Subject: TO CEP: Implications of cracked canisters [RETRY]

SUBJ: Implications of cracked canisters (and other emergencies).

San Onofre Nuclear Generating Station Exclusion Zone

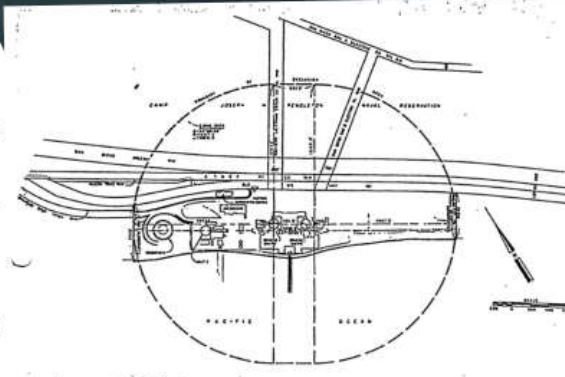
According to the San Onofre license, there is an exclusion area defined which encompasses a large section of the freeway, the frontage road, and the beach area which is easily accessible to the public. No signs exist informing the public that this is an exclusion area and concern for radiation to the public occurs at the boundary of this area.

The license also says that there must be a way to control traffic on the roads next to the plant but there is no control to this area of the freeway that I have seen. I would think they would have to install lights and gates at the previous overpass so cars can be easily stopped and turned away.

The diagram above is excerpted from the San Onofre operating license, and the map above it is the approximate outline when shown on a satellite map.

To make matters worse, the exclusion zone as calculated from a 1980s NRC document says the exclusion area should actually be more like 1km, which is about to the gates of the south state park and encompasses all of the popular beach area to the north. Unfortunately, SCE and San Onofre has violated the trust of the public by allowing the public to get very close to the plant. Again, the dose calcs ASSUME no one is in the exclusion area and a member of the public is NO CLOSER than the exclusion area. So those dose calcs are optimistically too low.
